REQUEST FOR PROPOSALS No. 26-034

GNPCC Grit & Sedimentation Tanks 2027 Refit Work

Addendum 6

Addendum 6a

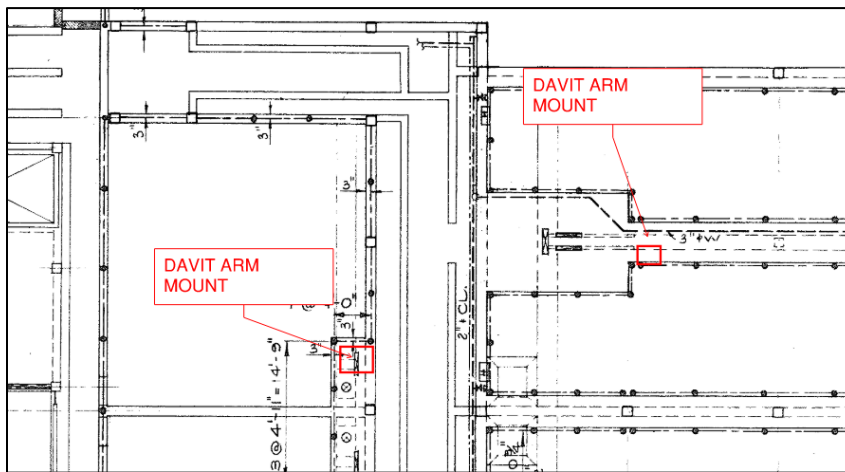
7. **Question:**

Can you confirm the davit arms the RDN uses for confined entry and the locations of the existing Mounts/Bases?

Answer:

See snip below for the davit arm approximate locations. Exact model will have to be confirmed during the work. All confined space equipment to be provided by the respondent.

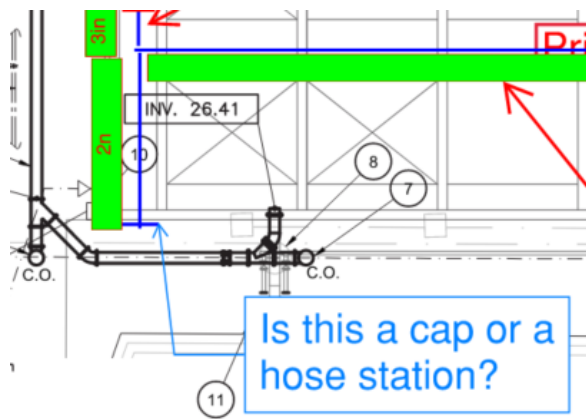
Appendix D item 1.1.7 calls for the replacement of a 3" water piping:

- Can you please confirm the size as the tie-in point did not appear to be 3" at the site meeting?

- If the piping is to be 3" is it to be grooved and if so what type of couplings and hardware is to be used?

- Is the end of the line to be a cap or a hose station?

Does the waterline require the heat trace to be extended?

The tie-point on the south side of the tank may be 2" will require a reducer if req'd. Contractor to confirm.

Threaded, or approved equivalent by the RDN.

- cap

No insulation or heat trace
